Historic Preservation Board

Wednesday, February 7, 2024 at 5:00 PM
Room 24, Basement Level of City Hall
and Via Zoom

TO: Chair O'Brien and Members of the Historic Preservation Board
FROM: Rob Wiener, Historic Preservation Compliance Coordinator
DATE: February 2, 2024
RE: 106 Pine Street - PUBLIC HEARING – Add Basement Access Door and Stairs
PROJECT ID: HPBR-002605
MEETING: February 7, 2024

**STAFF MEMORANDUM
HISTORIC PRESERVATION PROGRAM
PLANNING AND URBAN DEVELOPMENT**

1. SITE PLAN

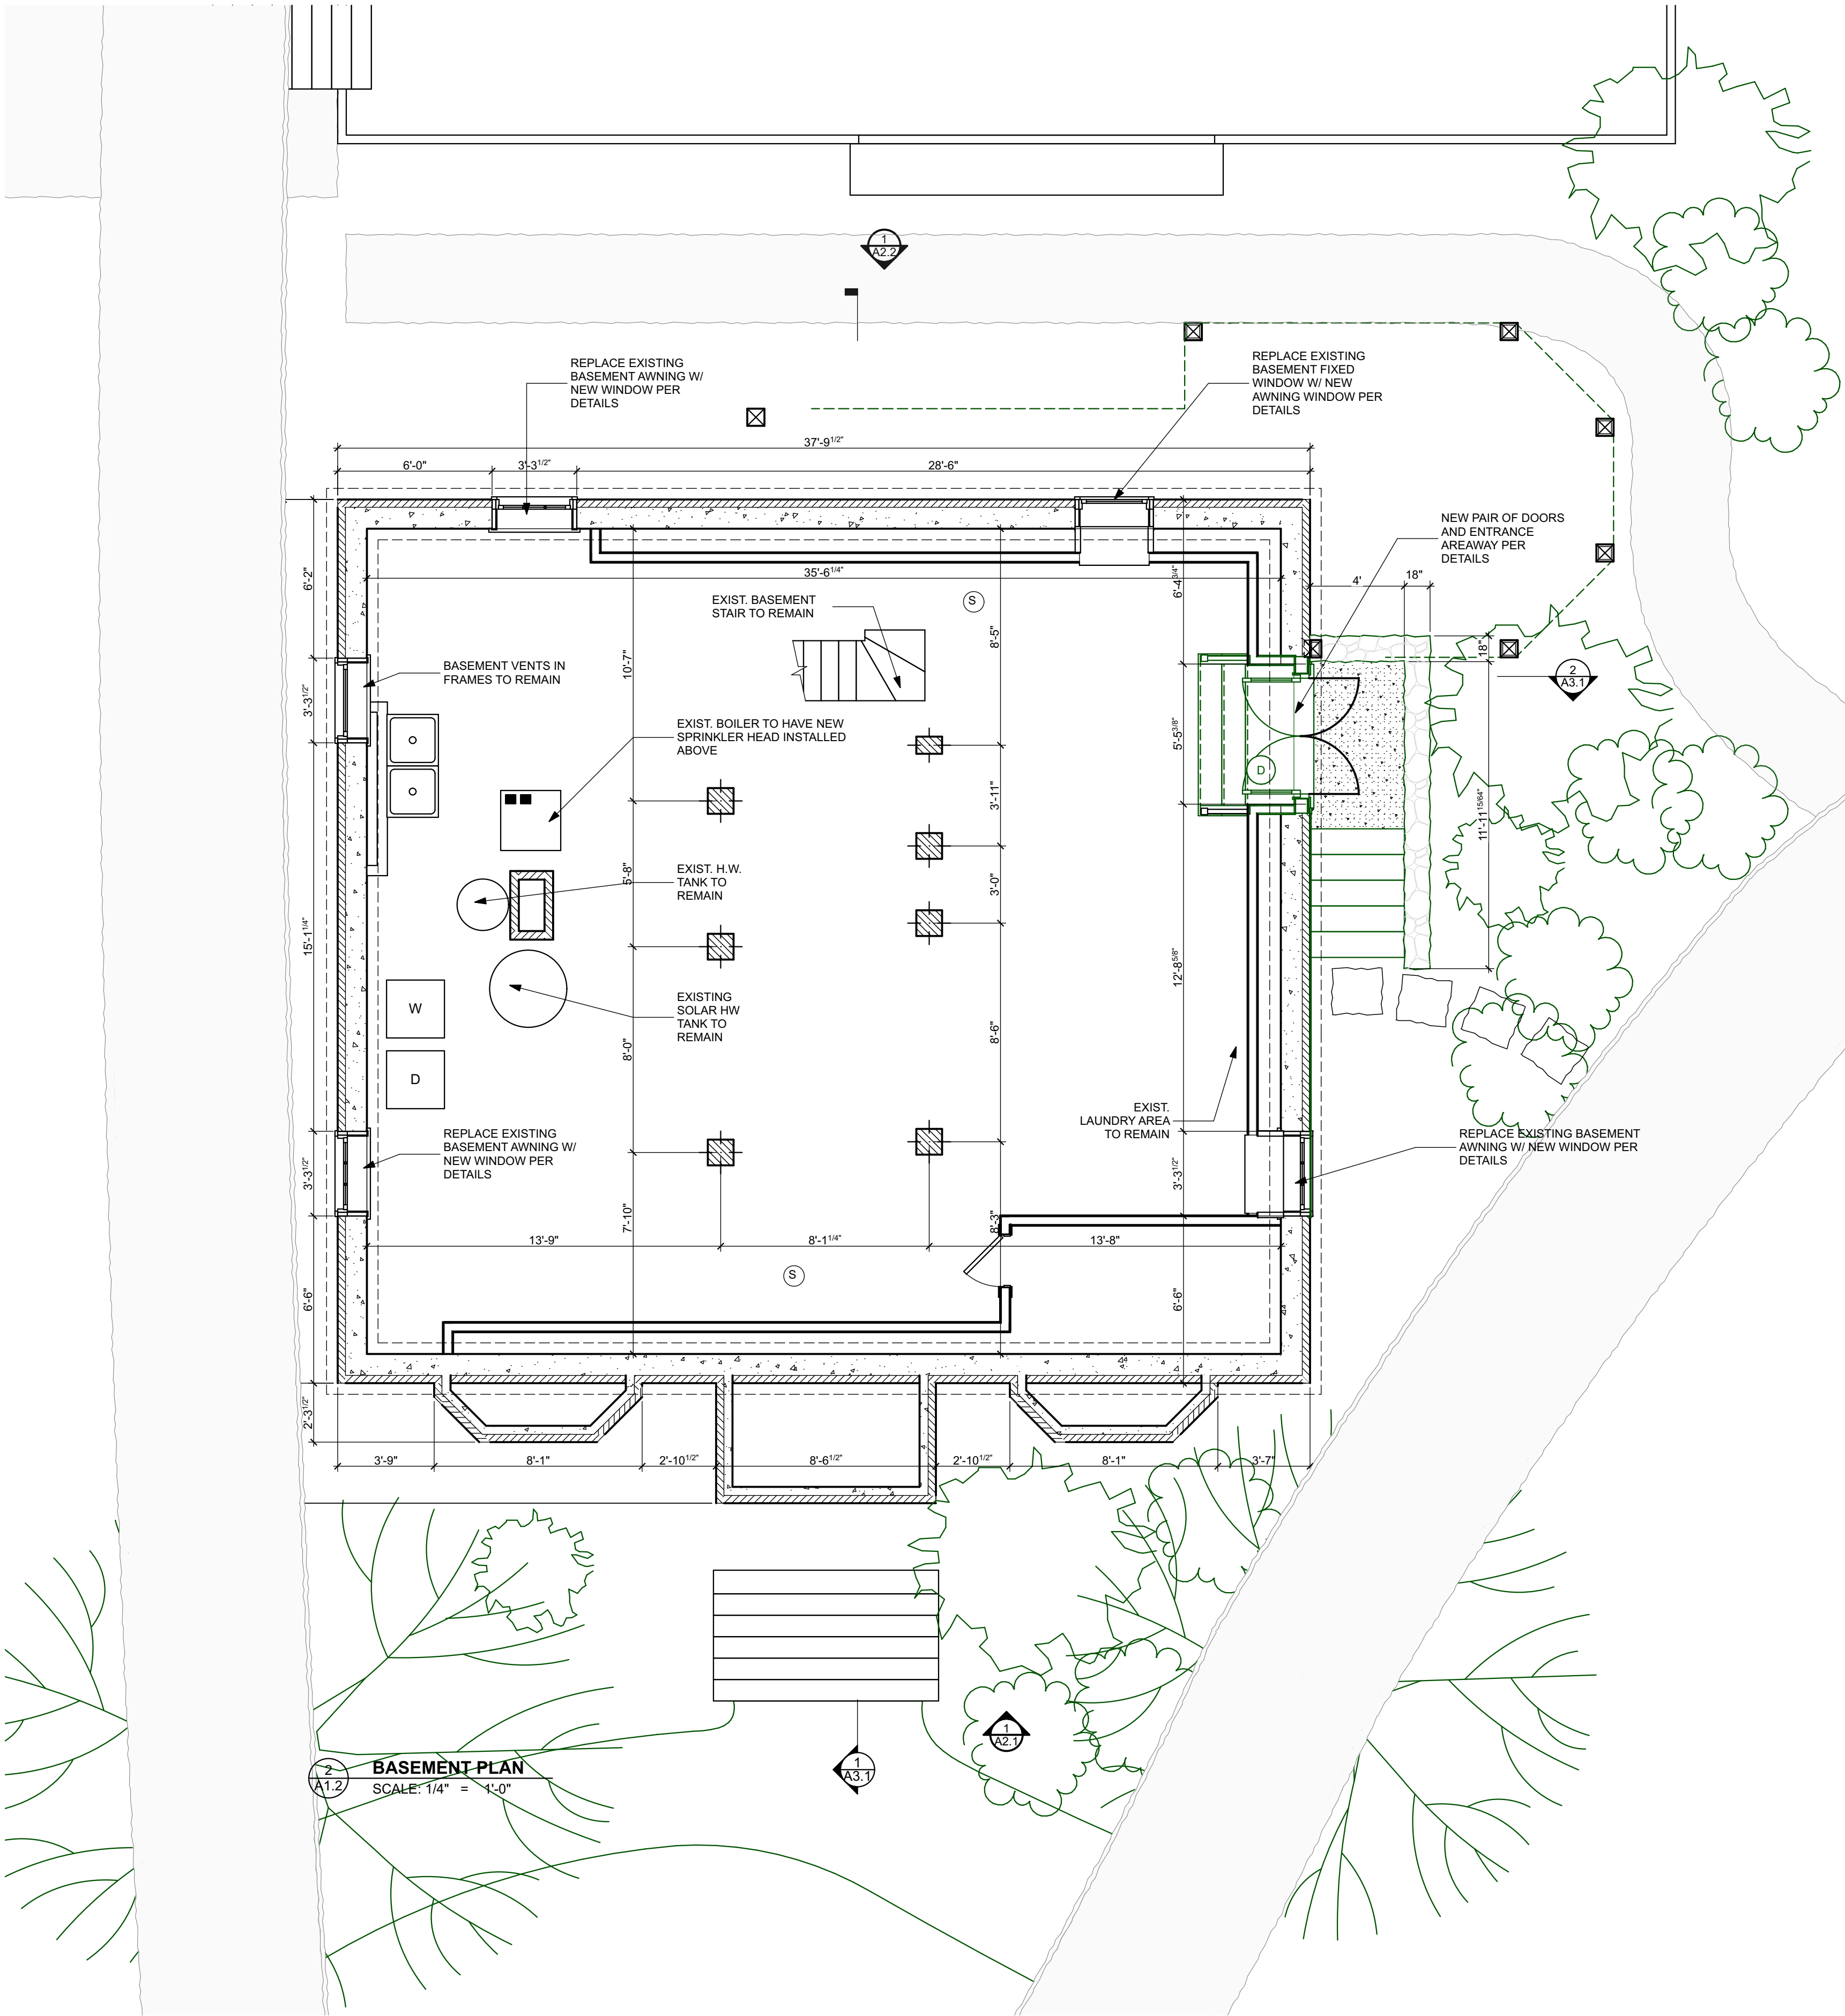
- Please provide details on lighting, handrail for the stairs, and the guard rail at grade.
- It was recommended that the visible guardrail should be a painted wood, traditional balustrade compatible with the nearby existing porch.
- Also recommended was enhancement of the garden path landing at the top of the stairs.

Mr. Delaney has followed the suggestions of the Board, and provided sufficient detail to present for approval at a public hearing. The drawing set and list of materials includes detailed information on the Marvin 15-light SDL doors, the painted aluminum handrail for the stairway, the guardrail around the stairwell, and lighting for the well walls. Also included is information for replacement of the existing basement windows, which according to the architect are in poor condition, with Marvin fiberglass windows. The proposed awning windows have simulated divided lights to match the existing three-light configuration. Staff recommends that the existing trim and sills on the basement windows be retained and repaired as needed, or replicated in-kind.

The proposed access stair will have flame faced granite treads and stacked stone retaining walls. Footings and piers are located/ hidden within the wall to anchor the posts for the proposed guard. We hope to work with Libby Masonry, who has visited the site. They felt that the small area of exposed existing foundation can be reworked with new stone for a consistent look. The guard will be painted wood as detailed and are designed to match the existing porch railings.

The proposed wall mounted painted metal handrail will be based upon aluminum profiles by King Metals. The graspable run will have a volute detail welded at each end. Two aluminum wall brackets will be provided. The aluminum will minimize corrosion/ staining and hold paint well.

The stair well will be lit with two step lights recessed into the stone wall. They are 3" x 5" and have dark bronze housings with full cutoff lights. The lights are located to be minimally visible from the sidewalk and to provide low level intensity.
